RE: Building Additions
22 Friars Drive
Tax Map 209, Lot 4, Hudson, NH

Date: March 17, 2022	Job #5734
Attn:	
Re: PROPOSED BUILDING ADDITIONS - SITE PLAN	
22 Friars Drive	
Hudson, NH

Re: Town of Hudson Planning Board Review
22 Friars Drive Site Plan, 22 Friars Drive
Tax Map 209 Lot 4; Acct. #1350-993
Reference No. 20030249.2130

**SIDEWALK SKETCH PLAN
MAP 209, LOT 4
22 FRIARS DRIVE
HUDSON, NH
03/16/22**

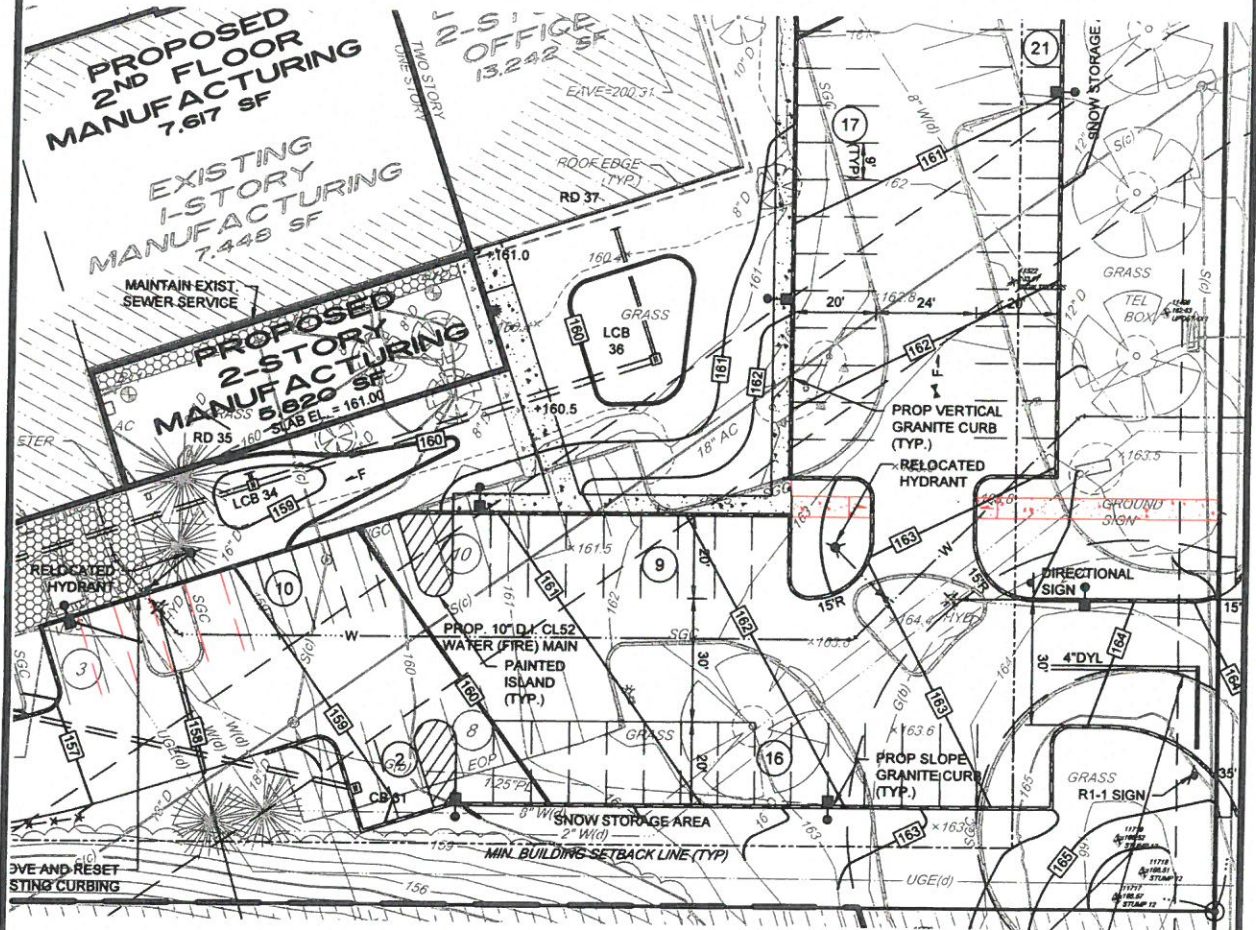
- a. *Former Fuss & O'Neill Comment: Hudson Regulation (HR) 275-6.C. The site currently contains an existing sidewalk, and the applicant has proposed to reconstruct the sidewalks in the areas that the new driveways will disturb. The applicant has proposed construction of a four-foot-wide bituminous sidewalk where the Town requires a five-foot-wide sidewalk.*

Current Fuss & O'Neill Comment: The applicant has stated that they have proposed to match the existing sidewalk width of 4 feet. The Town should confirm that this is acceptable and review if a waiver is required.

3. Please find attached a sketch plan showing the sidewalk connection from Friars Drive to the on-site sidewalk network that leads to the building entrances. If acceptable we will add this information to our final plan set.

PROPOSED PLOT PLAN

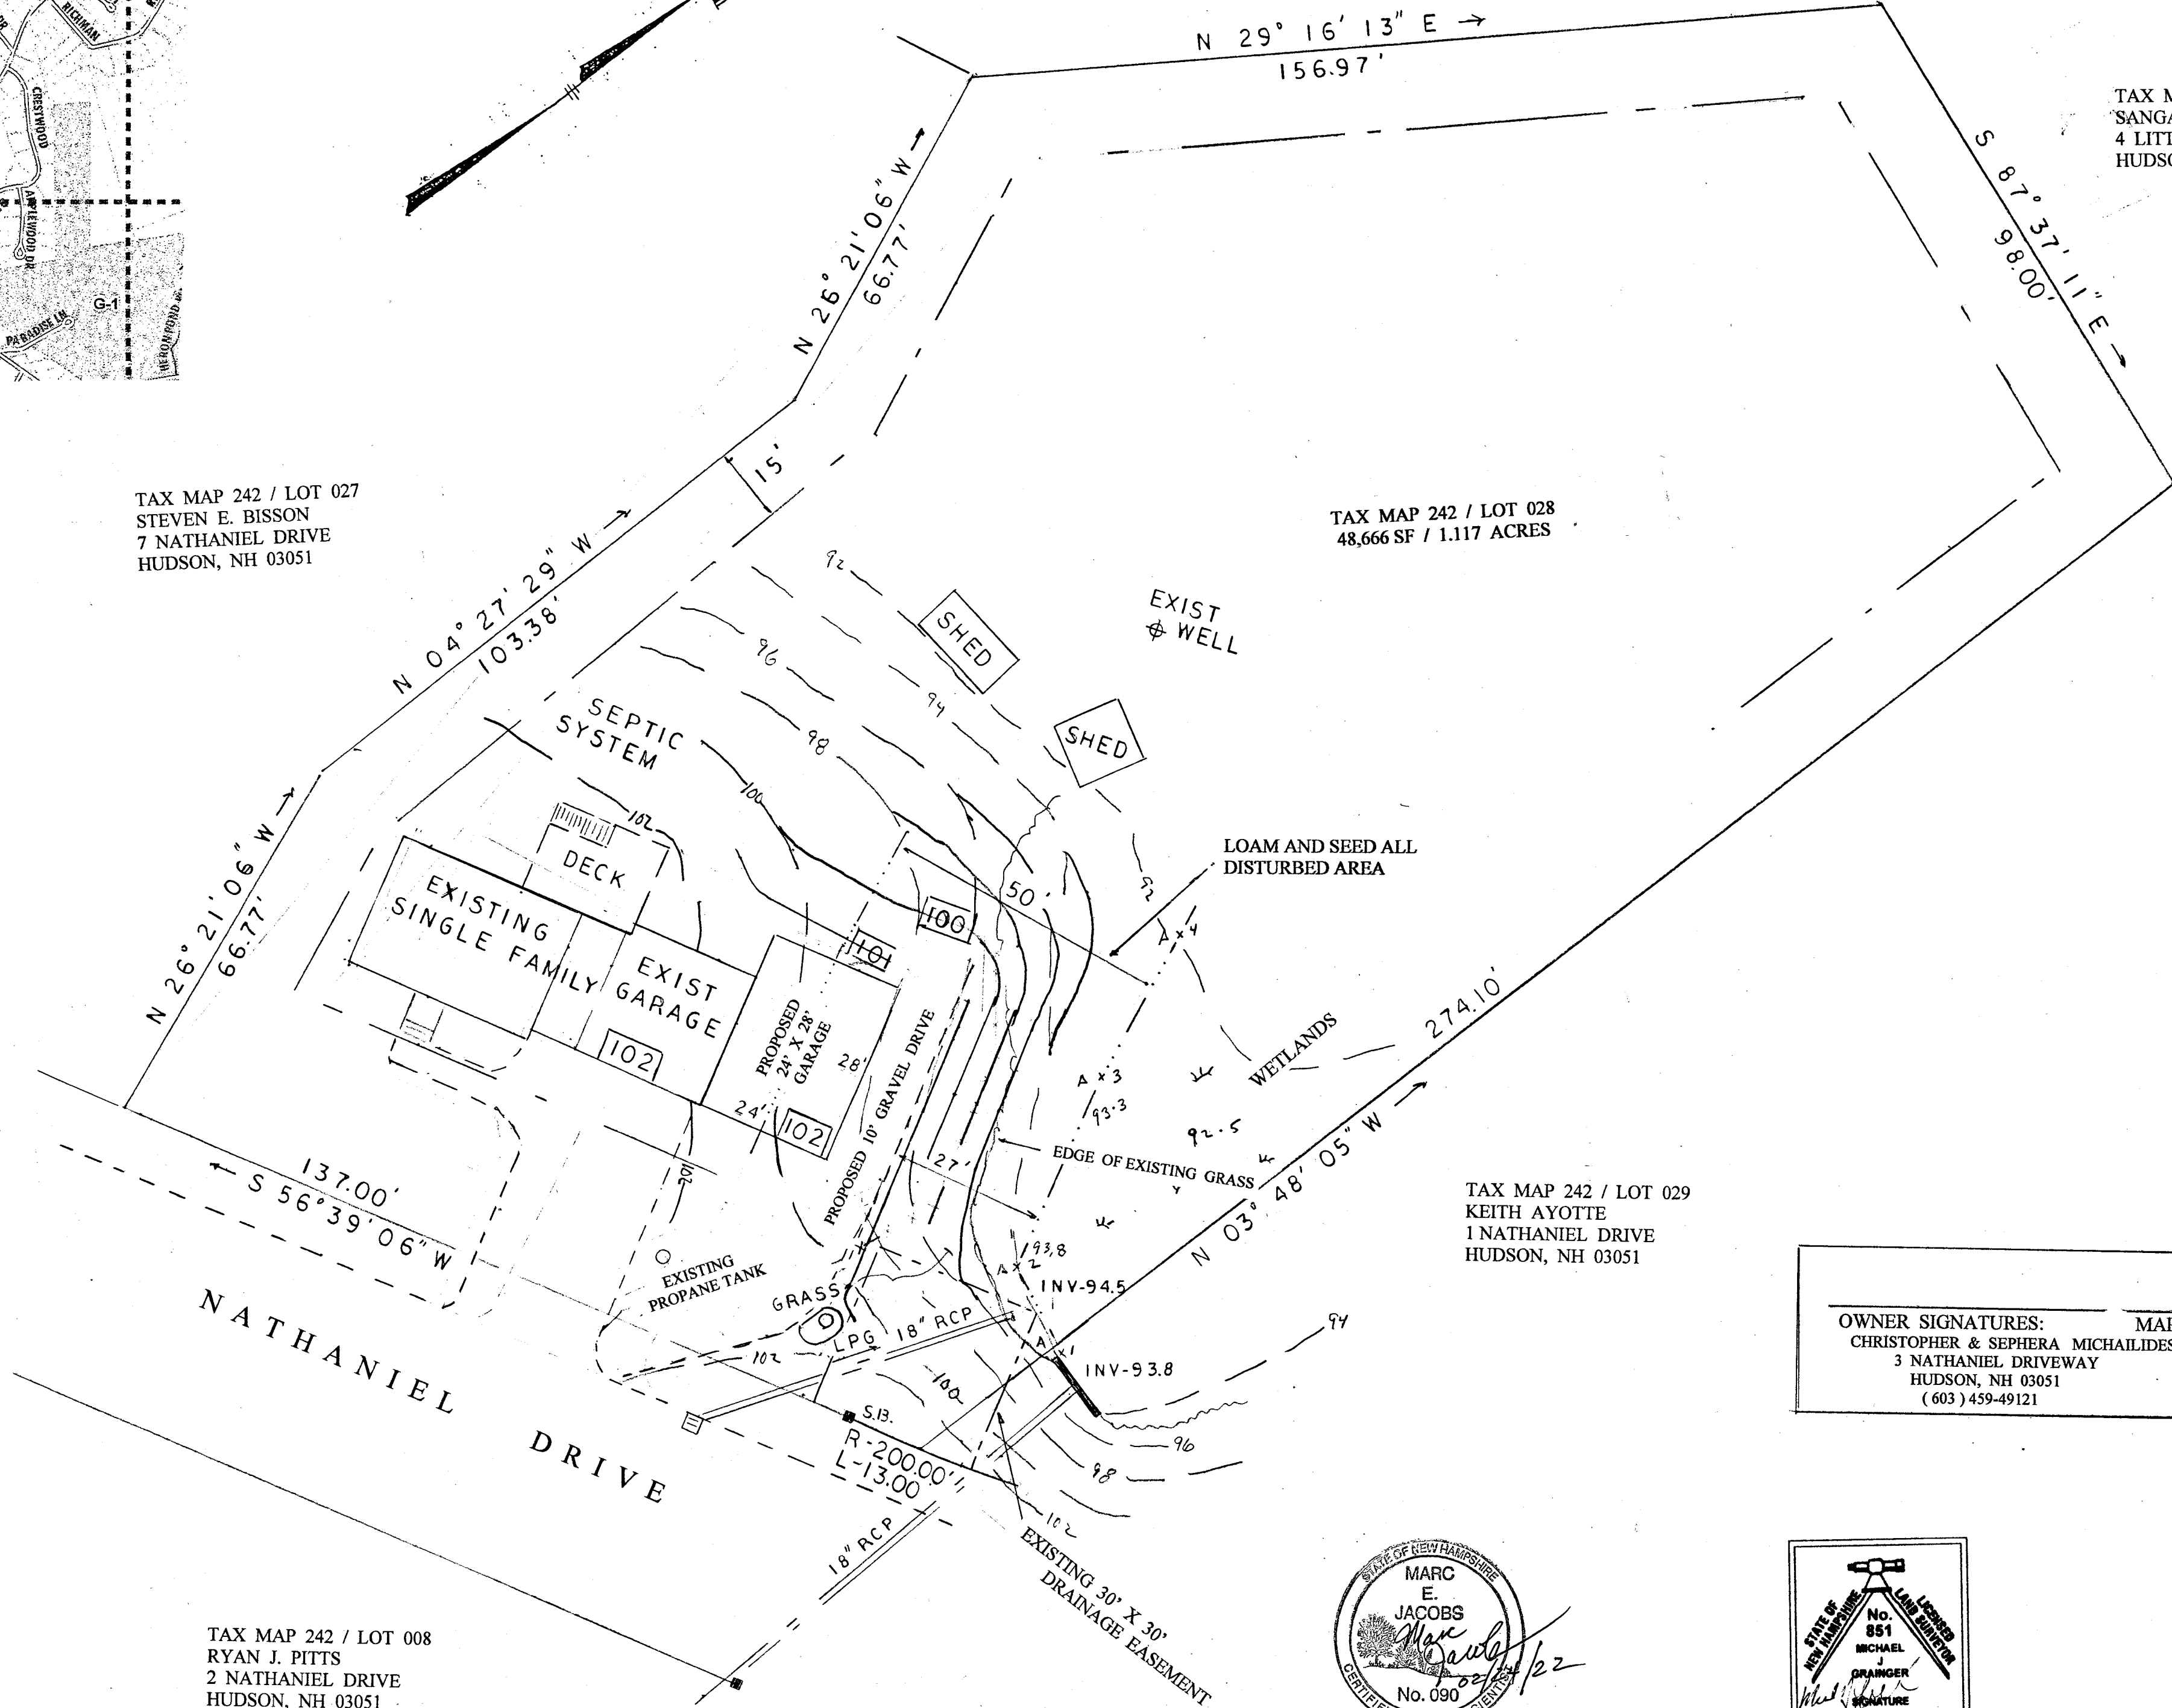
- 4) The applicant shall remove tree debris pile that was placed in the wetlands.
- 5) The applicant was looking to add a paved driveway alongside the proposed garage addition for access to the rear yard area. The plan presented to the commission shows a gravel access way 10 foot wide in that area. It is recommended by the commission that to reduce further impacts and degradation to the WOCB buffer (per 334-37 paragraph A), that no asphalt or other non-permeable materials be used alongside the garage addition as it will reduce storm water infiltration and pollutant attenuation and possibly cause slope erosion within the wetland buffer area.

- 6) There was no post construction restoration or landscaping plan presented and with a slope of approximately 2 to 1 leading down to the wetlands the commission recommends that the applicant relocate shrubs that are currently located in the area of the proposed gravel driveway further down the slope to increase stabilization. It would also be desirable that some re-naturalization of the wetland buffer be a goal to occur around the wetland. This would help attenuate nutrients from lawn fertilizers and other sources of non-point pollutants.
